AGENDA
SOUTHERN CORRIDOR REVIEW BOARD
Wednesday, May 8, 2013
3:00 P.M.

STAFF REPORT – SOUTHERN CORRIDOR REVIEW BOARD DEPARTMENT OF GROWTH MANAGEMENT

MEETING DATE:	May 8, 2013
PROJECT:	Parker’s Convenience Store – Certificate of Appropriateness – Highway Corridor Overlay
PROJECT MANAGER:	Erin Schumacher, Senior Planner

Landscape Plan
Sheet No.
LS-101

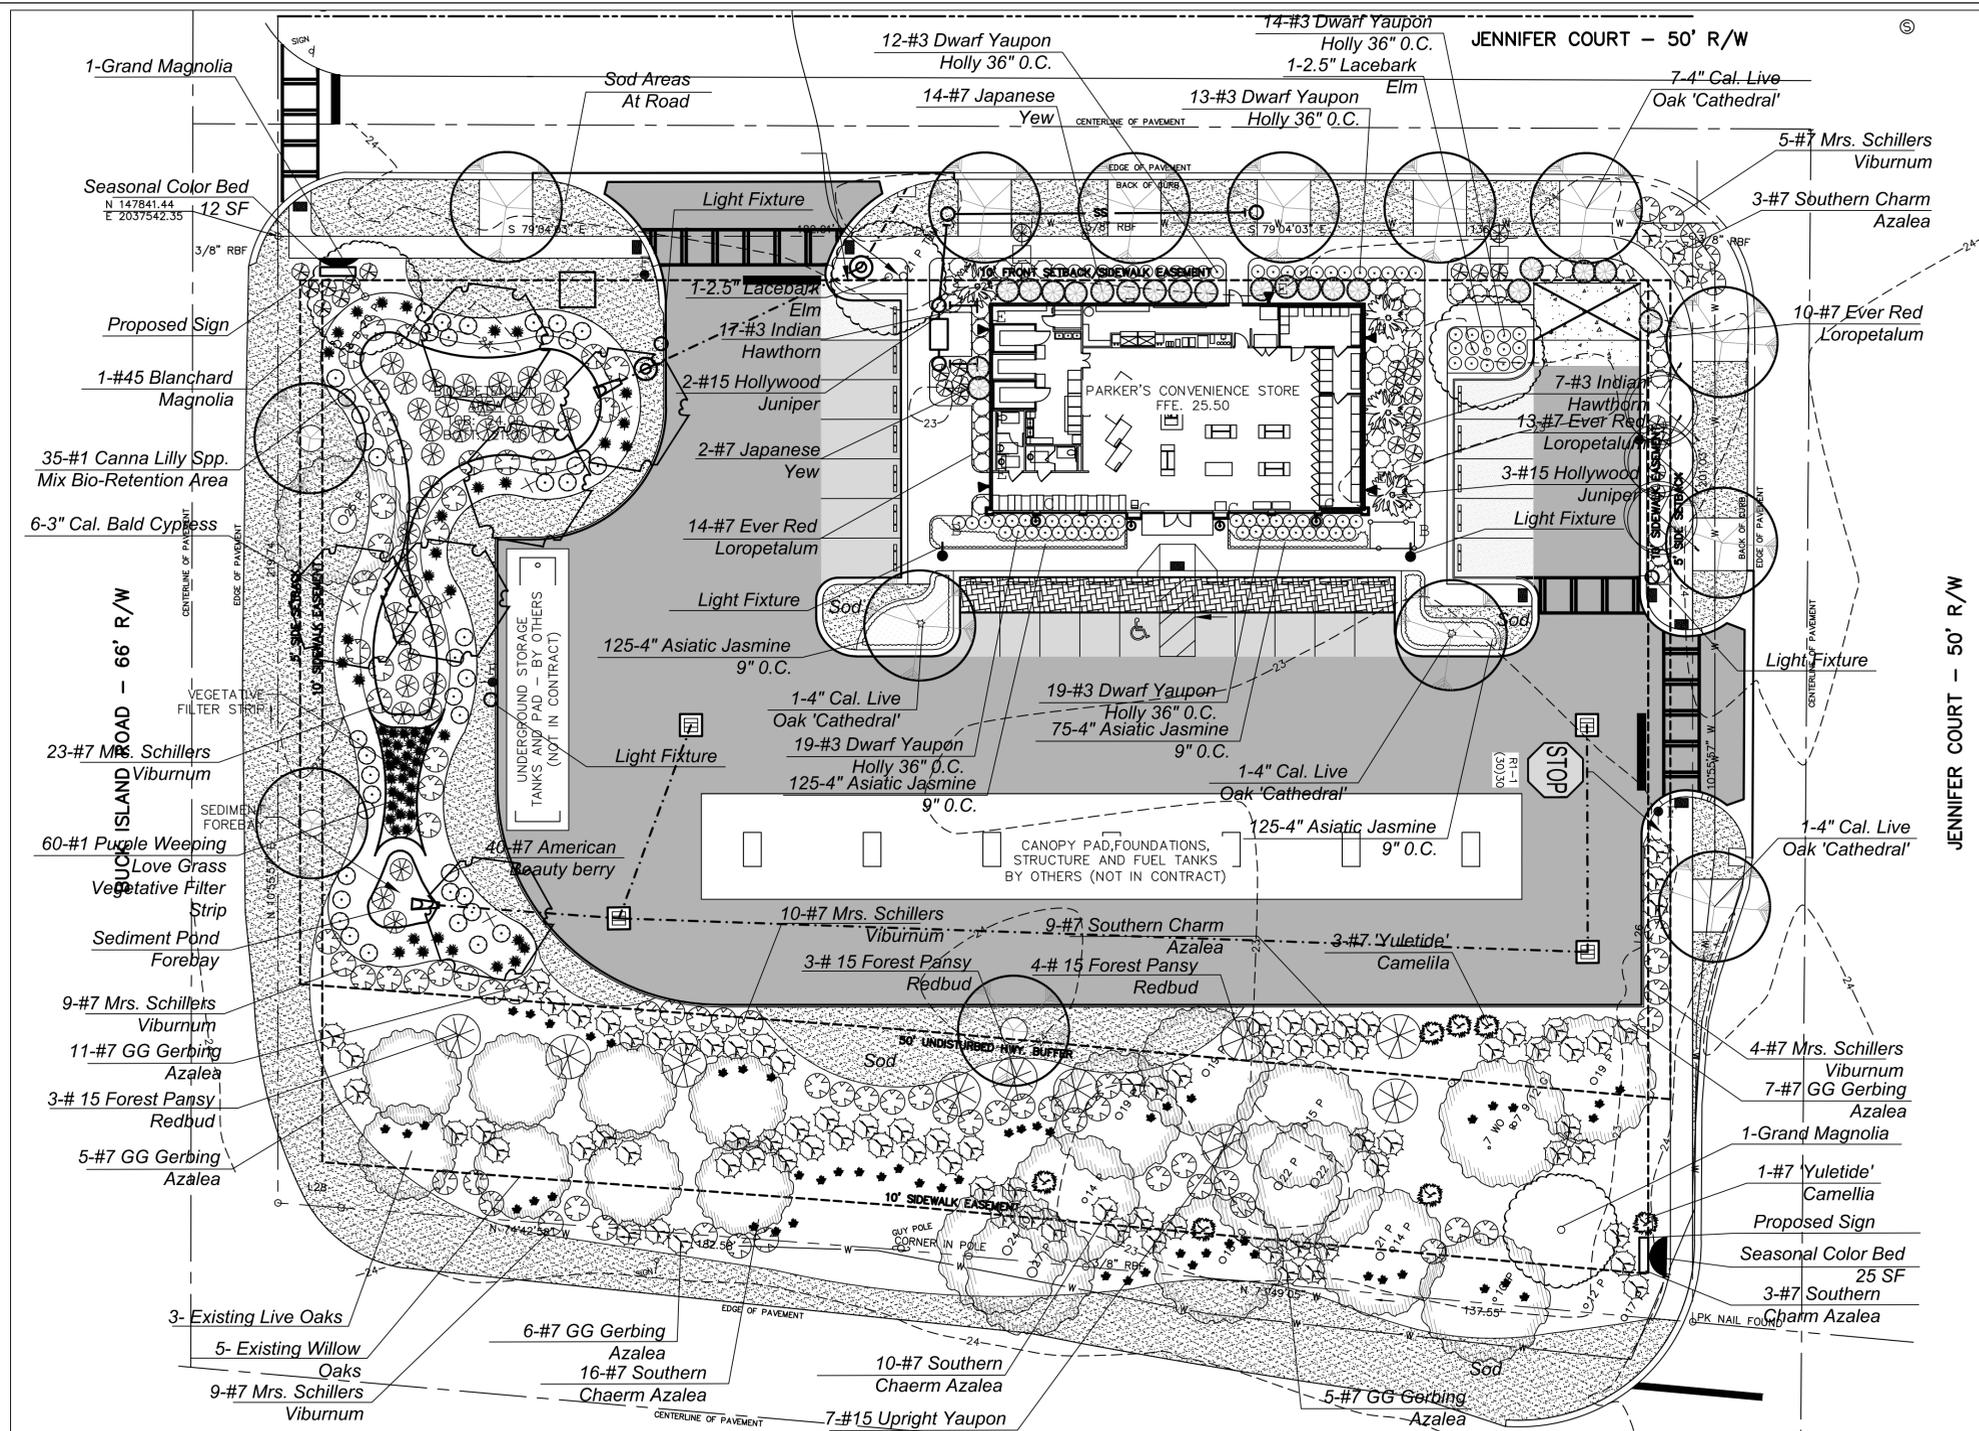
- 1) *Landscape Materials*
 - A. Section 5.3.4.A. Regional appropriateness. The UDO states that native and regionally appropriate plant species are required. Currently, several of the types of proposed plant materials are not native or regionally appropriate and are not aligned with what is commonly found along the May River Scenic Byway. The use of Japanese Yew, Hollywood Juniper, and Indian Hawthorn are not suitable for use along on the site as these are not native species to the region. These materials must be replaced by the Applicant with native, regionally appropriate species.

- B. Section 5.3.4.H. Diversity of species. The UDO requires that no more than 15 percent of plant material shall be of the same species. As proposed on the current landscape plan, Dwarf Yaupon Holly comprises 21 percent of the shrub plant material and Walter's Viburnum 'MSD' comprises 20 percent. For hardwoods, the Red Buds compose 27 percent, the Cathedral Oaks make up 36 percent, and the Bald Cypress comprises of 16 percent of the plant material. The amount used of these species

- A. Section 5.3.5.B. Lack of root barriers. The UDO states that root barriers shall be installed within tree lawns less than 7 feet between the back of the curb and the sidewalk to prevent root penetration and destruction of infrastructure. Currently, the plan does not provide this on Jennifer Court. The Applicant must revise the plan to provide root barriers.

- A. Section 5.3.7.A.1. Street trees. The UDO requires that all roadways in which development is proposed shall include large canopy street trees that are planted no greater than 50 feet apart. The two street trees proposed for Buck Island Road do not meet this requirement as they are over 50 feet apart. The Applicant must provide more street trees along Buck Island with adequate spacing in order to meet this requirement.

- B. Section 5.3.7.B.1. Screening around transformer. The UDO requires that area buffer be provided to separate and screen incompatible land uses. The Applicant is proposing to locate a very large electrical transformer near the intersection of Buck Island Road and Jennifer Court. Currently, the transformer is not screened as per the landscape plan. The Applicant must provide adequate landscaping around the transformer in order to mitigate the visual impact.

- C. Sections 5.3.1 and 5.3.7.B.3. Formal style of planting. The landscape plan, as proposed, is formal in character and does not reflect the casual style of the May River Scenic Byway of which this site is a part, as well as a the entry gateway to Old Town Bluffton that this site serves. While a more formal landscape pattern can be appropriate to the interior of the site, the edges and required buffer must reflect the casual, informal context of the May River Scenic Byway. This formal landscape pattern is most evident by the sculpted use of sod throughout that does not fit with the Scenic Byway character. The Applicant must remove sod from the buffer, replacing it with appropriate over and understory plant material.

D. Section 5.3.7.B.2. Adequate screening material. The UDO requires that the absence of adequate natural vegetation, additional landscaping shall be installed into the required buffer. The buffer needs to consist of a sufficiently multi-layered vertical and horizontal screening to achieve a consistent and visually dense buffer from the adjacent right-of-way. At present, the landscaping plan contains gaps in the upper canopy along May River Road. The identified gap appears as a result of an underground conduit for electrical service. This conduit can be relocated out of the required buffer or at a minimum planted over without an adverse impact to the provision of electrical service. The Applicant must provide additional plantings in this area.

- a. Per Section 5.3.4.A, in order to provide plant materials that are native or regionally appropriate, remove the Japanese Yew, Hollywood Juniper, and Indian Hawthorn species from the landscape plan and replace with appropriate vegetation as these are nonnative or regionally inappropriate plants.

- b. Per Section 5.3.4.H, in order to promote a diversity of species, reduce the amount of an individual plant material used so that there is no more 15% of the same species. Groundcovers are not included in this calculation.

- c. Per Section 5.3.5.B, provide for root barriers for the trees planted within the tree lawn along Jennifer Court.
- d. Per Section 5.3.7.A.1, provide more street trees along Buck Island Road to meet the requirement of providing a street tree not more 50 feet apart.

- e. Per Section 5.3.7.B.1, provide a landscape screen around the proposed electric transformer.
- f. Per Section 5.3.7.B.2, to provide adequate screening materials through the buffer area and to achieve a consistent, multi-layered, and visually dense buffer, add additional plantings in the buffer area, particularly in the opening where the underground electrical service is being install.

- g. Per Section 5.3.7.B.3, to promote a less formal landscape pattern along the edges of the site, especially in the May River Road buffer, consistent with the Bluffton Historic District and May River Scenic Byway, remove the sod proposed in the buffer and replace it with over and under-story vegetation that promotes a less formalized style of planting.

Canopy Plan
 Sheet No.
LS-102
 SHEET 1 OF 1

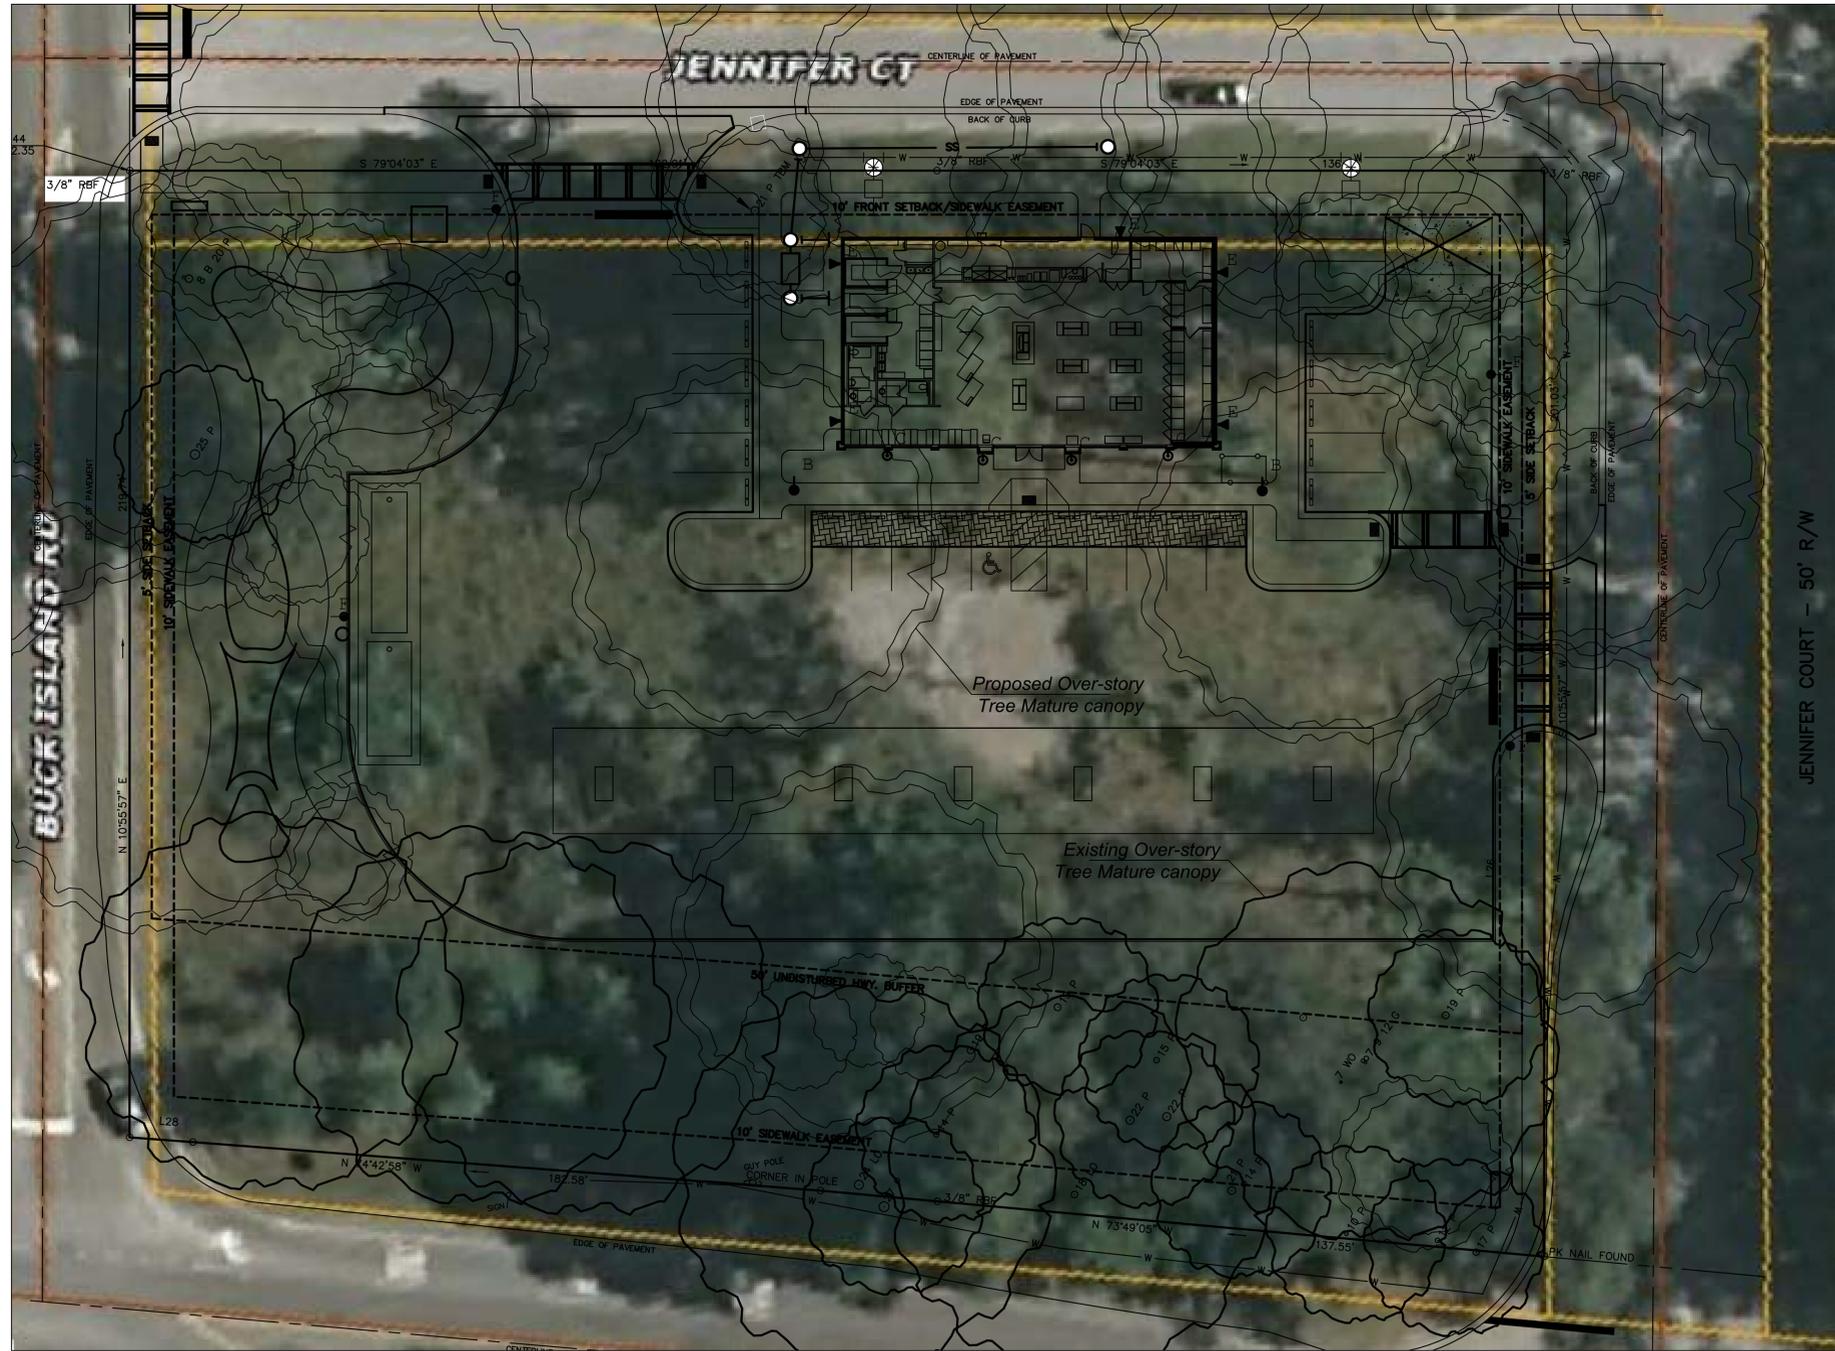
A. Section 5.3.7.D.1. 75 percent canopy coverage. Per the UDO, all lots shall contain sufficient landscaping, either existing or planted, to have a minimum of 75 percent lot coverage with tree canopy measured as the mature canopy, not including building rooftops. The proposed overstory that was provided in the canopy area plan falls just below this requirement, at 74.3% and does not comply with this standard. The Applicant must provide additional tree plantings to meet the minimum canopy coverage requirements.

- h. Per Section 5.3.7.D.1, add additional tree plantings to increase the canopy coverage to the required 75 percent, at a minimum.

CRS-AC-LED-64
LED Crossover Gold Asymmetric Canopy Light

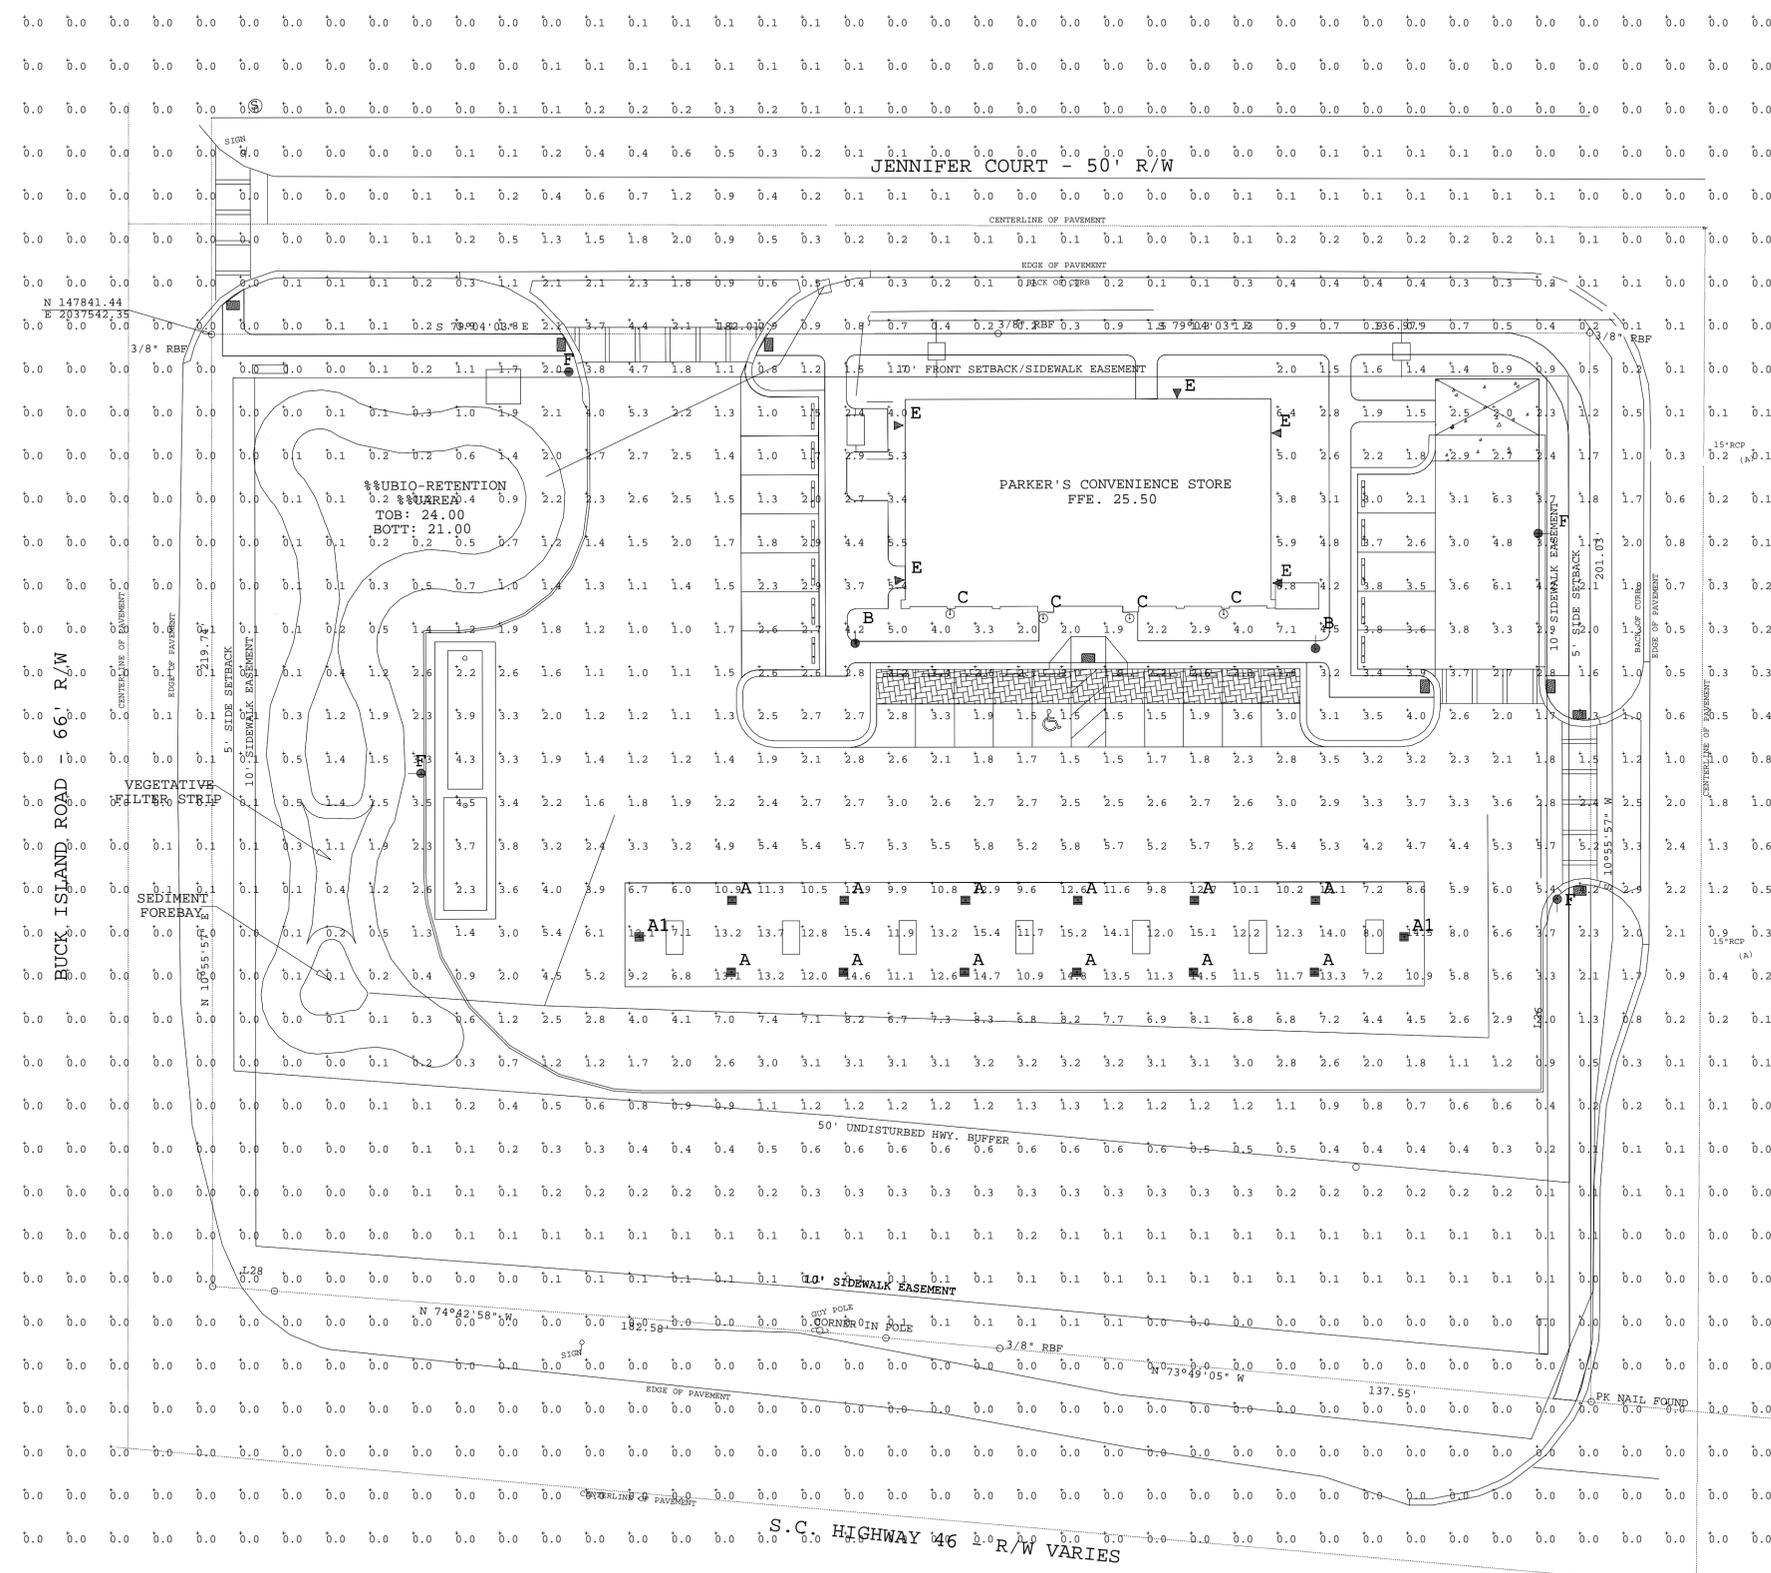
A. Section 5.12.3.A.3. Minimize ambient lighting. The UDO requires that all exterior lighting visible from the corridor shall be generated from a concealed light source with low-level fixtures, and shall be of such design as to minimize the amount of ambient lighting perceptible from adjacent properties. The proposed lighting plan allows ambient lighting off of the site that does not meet this requirement. The Applicant must revise the lighting source, fixture locations, and/or provide shielding to eliminate all ambient light perceptible offsite.

A. Section 5.12.B.3. Consistency in lighting. The UDO states that the same type of lighting must be utilized for all fixtures and light sources on-site. The lighting proposal includes two different types of lighting, an LED light that emits a high temperature light and is white, and lower temperature high-pressure sodium lights that emits a soft yellow light. The Applicant must revise the lighting plan to be consistent with the type of lighting that is used on-site as well as the metal halide light used along May River Road. In order demonstrate that the lighting is consistent, the Applicant must include the Kelvin color temperature for each of the light sources.

- a. Per Section 5.12.3.A.3, revise the proposed lighting source, fixture locations, and/or provide shielding to minimize the amount of ambient lighting perceptible from adjacent properties.
- b. Per Section 5.12.3.A.5, update the lighting plan to include interior lighting, demonstrating that the light source or high levels of light are not visible from the corridor.
- c. Per Section 5.12.3.B.3, revise the proposed lighting to provide a consistent color and quality of light across the site that also matches the existing lighting characteristics found in Old Town Bluffton and the recently installed street lighting along May River Road.
